Environmental Assessment

Paonia Dam Intake Structure Repair

WCAO-GJ-EA-2016-03

October 2016

Figure 8. Hydrograph of Paonia Dam releases with a functioning outlet compared to predicted releases without a functioning outlet, based on the 2002-2015 average releases.

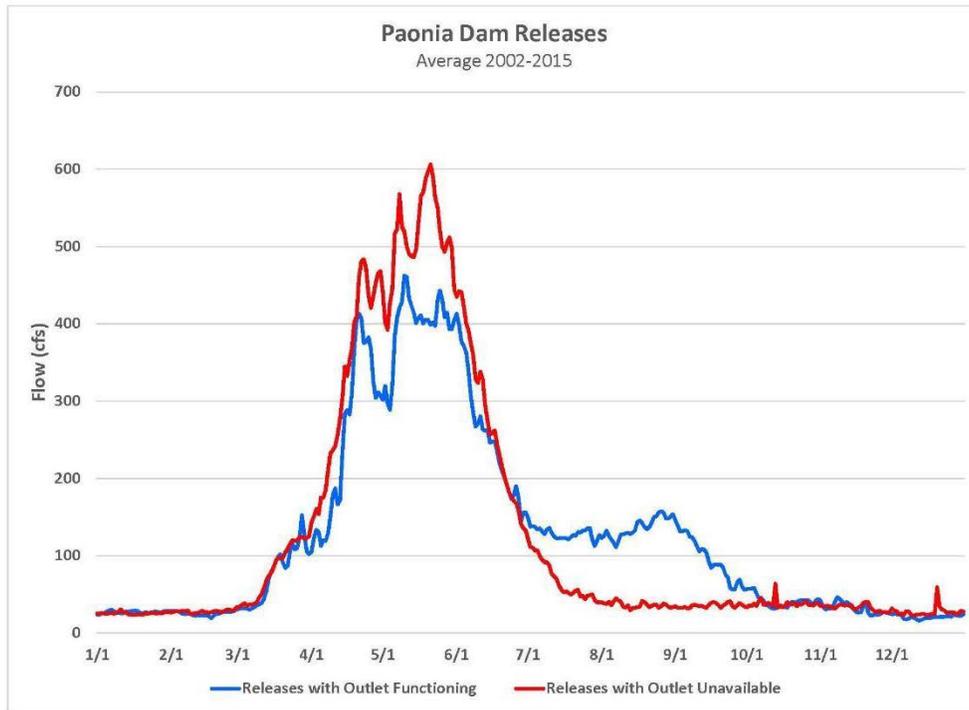
Comment 9:

Under the No Action Alternative, repair of the damaged bulkhead of the intake tower would not be completed (see Section 2.1) Due to the observed damage to the concrete bulkhead, pieces of broken concrete could fall into the outlet works at any time, rendering the outlet works inoperable. The proposed action to repair the intake structure is a single and complete project that is not part of the development, planning, and implementation of a long-term sediment

management alternative. Delaying the repair work until implementation of a long-term sedimentation management strategy would increase the risk of the outlet works becoming inoperable, which would affect the ability to deliver water and affect flood control functions. This has been clarified in Section 2.2 of the EA. Effects of a non-functioning outlet works structure are depicted in Figure 8.

Figure 10 - Cross-Sections and Pebble Count Surveys performed by USGS in fall 2015 (provisional data). The green triangle (river left bank) and red square (river right bank) are the water surface elevation at the time of survey. Cross-sections are oriented looking upstream.

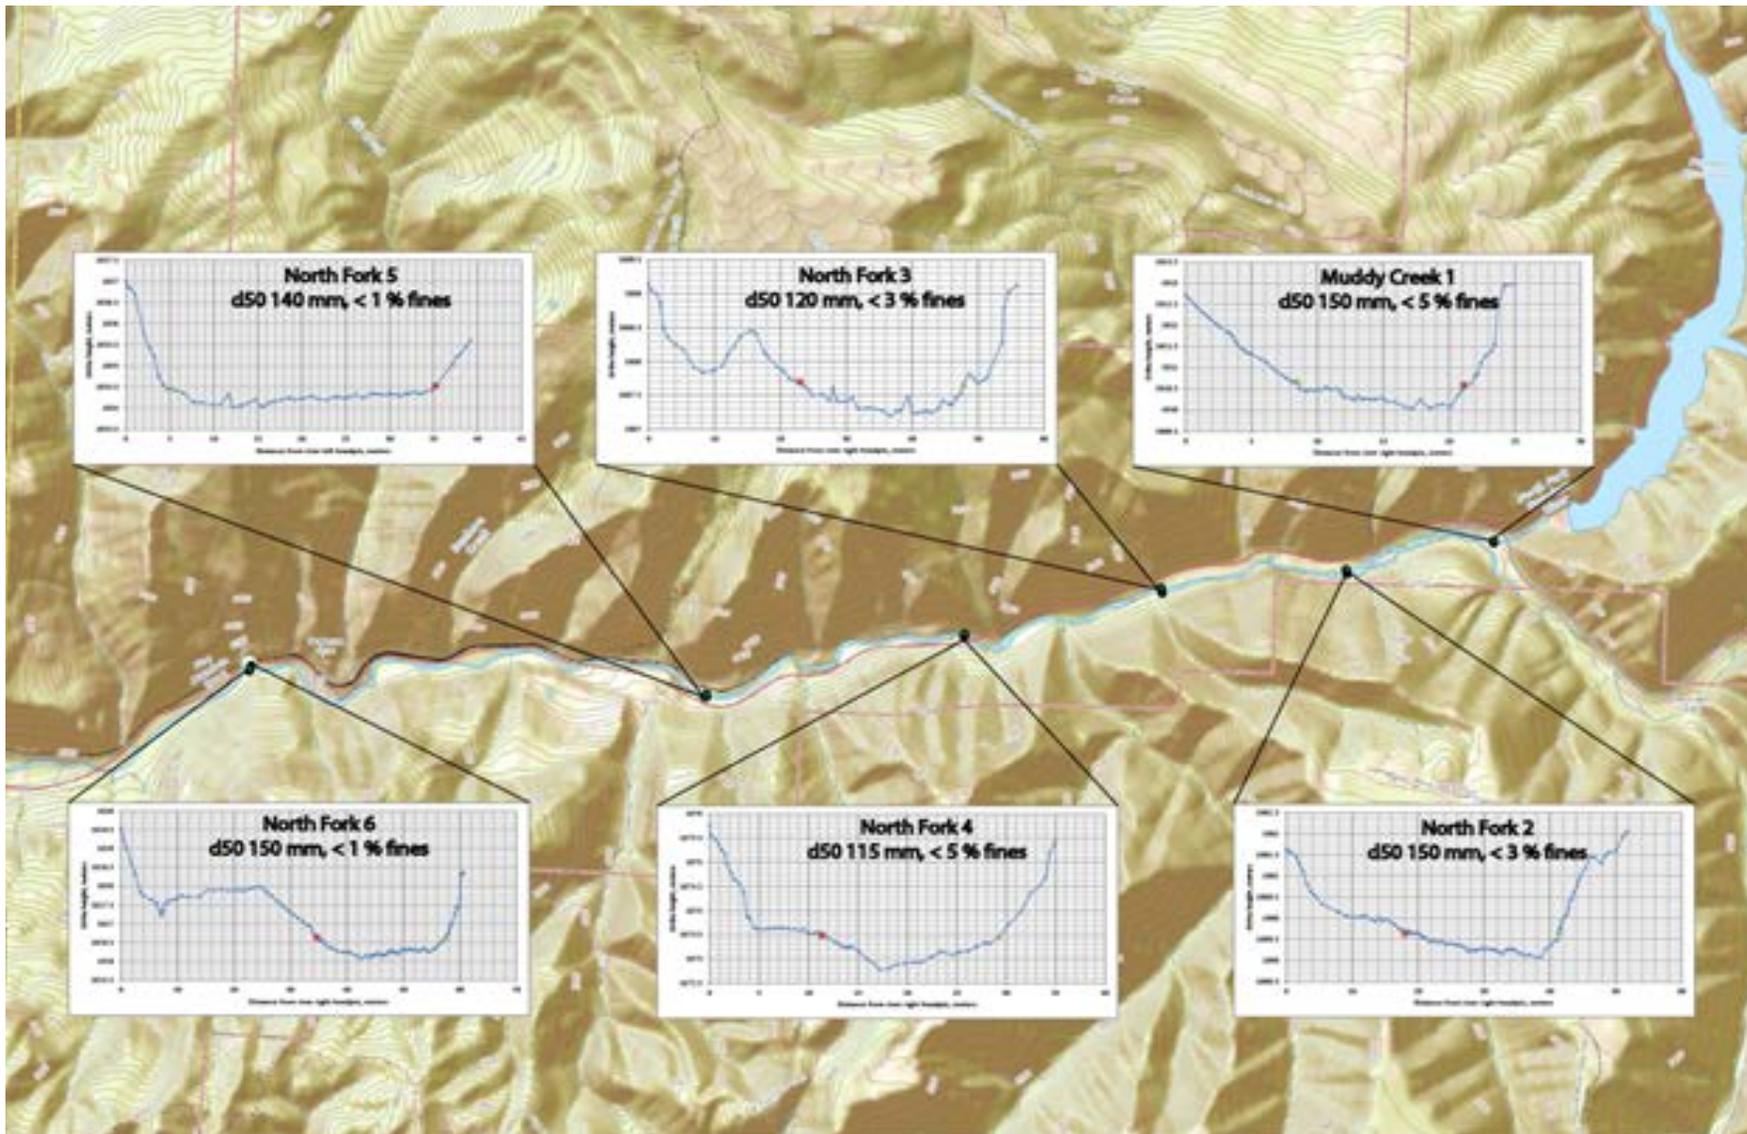
Comment 3:

Boiler plate data, and glossed over scenarios will not change the fact that unnatural sedimentation on the downstream stretches of the river will have negative effects on the ecology of the river over the course of succeeding years.

In fall 2015, less than one year following the fall 2014 sediment release, provisional USGS cross-section and pebble count data (Figure 10) showed fine sediment accumulations were well below the 29.3% fines threshold for protection of macroinvertebrates defined in the Colorado Department of Public Health and Environment Policy 98-1 for Region 2 (CDPHE 98-1), and well below the 20% guideline for salmonid spawning habitat (CDPHE 98-1). All six data collection sites were exposed to the much larger fall 2014 sediment release. Because the fines percentages are well below the Policy 98-1 thresholds, Muddy Creek and the North Fork Gunnison River are not impaired for beneficial or classified uses due to sedimentation, despite the 2014 sediment release. This information has been included in Sections 3.3.2.2 and 3.3.6.2 of the Final EA.

Figure 12. Graph of Total Suspended Solids Average (2001-2013) Compared to Release Estimates created by Western Slope Conservation Center and included in their comment letter.

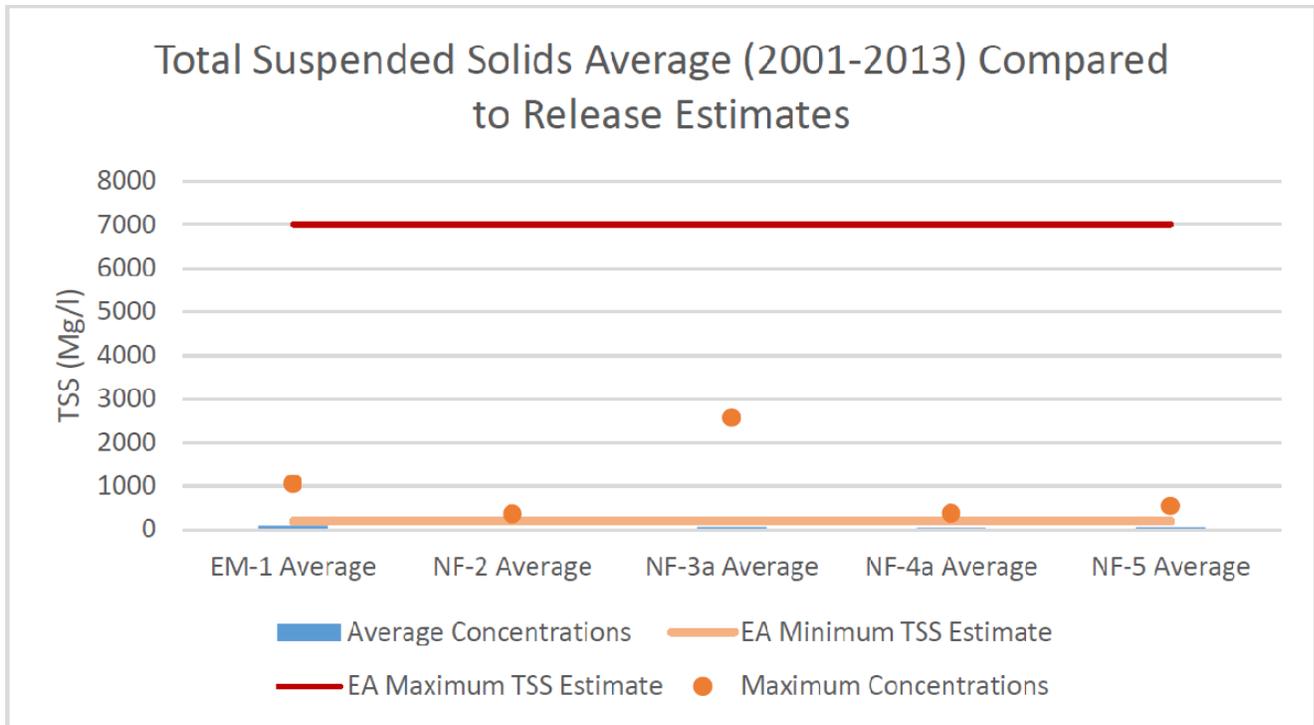
Comment 5:

This range of total suspended sediment (TSS) concentrations is concerning when compared to average TSS concentrations below the Paonia Dam on the North Fork of the Gunnison River. According to River Watch data gathered between 2001 and 2013, the average total suspended solids (TSS) concentration below the Fire Mountain canal diversion (station NF-2) was 37.82 mg/l and the maximum TSS concentration was 358.8 mg/l (see figure below). This data does not include the 2014 release.

Response 5:

The suspended sediment concentrations referenced in the EA are projections of suspended sediment concentrations exiting the reservoir. These concentrations would decrease as the suspended sediment progresses downstream to the data sites referenced in Western Slope Conservation Center's letter, due to dilution from tributaries. Data collection efforts by Reclamation and USGS above the reservoir and below the reservoir show that the reservoir retains a large volume of sediment, preventing it from entering the downstream system, which creates a "cleaner" environment downstream. Data stations have been established specifically for this project to monitor the fluctuations in the system in relation to reservoir operations and in comparison to natural conditions above the reservoir. This data is available to the public at: <http://co.water.usgs.gov/> and <http://waterdata.usgs.gov/co/nwis/qw>. As disclosed in the EA, the proposed work is anticipated to increase the suspended sediment concentrations above accustomed normal ranges. A section discussing sedimentation has been included in Section 3.3.2.2 of the Final EA.

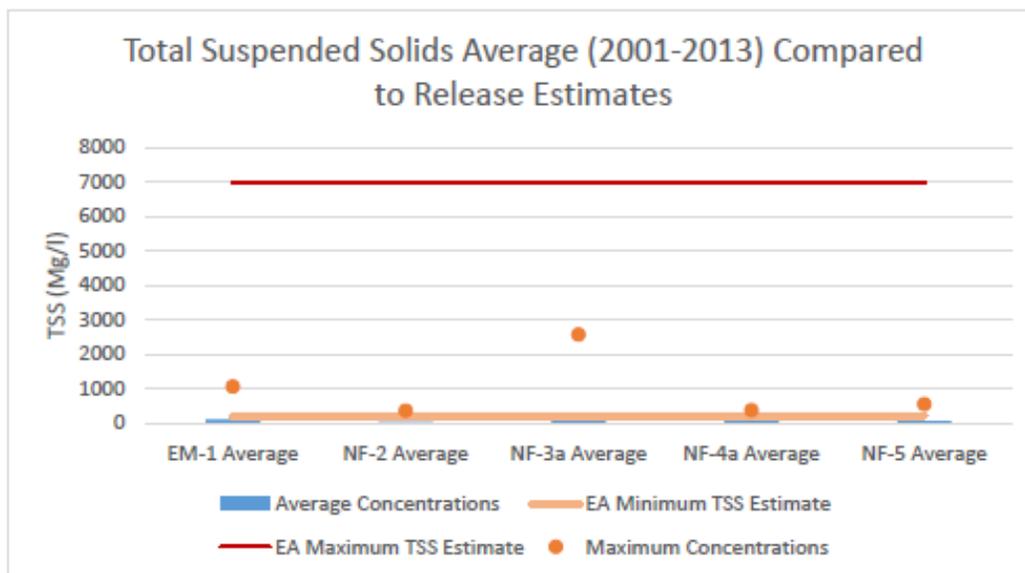
Sediment Impacts:

The current EA does not take into account the possibility of low water for the upcoming winter and spring (2017 CO water year) nor does it evaluate the full scope of possible sediment impacts that could occur with varying sediment releases and flows. The Conservation Center is concerned with the possibility that in the case of low flows, the NFWCD, Fire Mountain Canal Ditch and Reservoir Company, and BOR will be unable to meet the needs of users dependent on irrigation water while also protecting the health of the watershed by flushing the released sediment downstream below threshold dilution levels.

The Western Slope Conservation Center is concerned that the EA does not adequately address contingency plans in the case of a low water event in the Muddy drainage during the first half of the 2017 CO water year. In the case of a low water event, the proposed construction could result in sediment loading which could significantly impact downstream water quality including fisheries, macroinvertebrate, wetland, and riparian health.
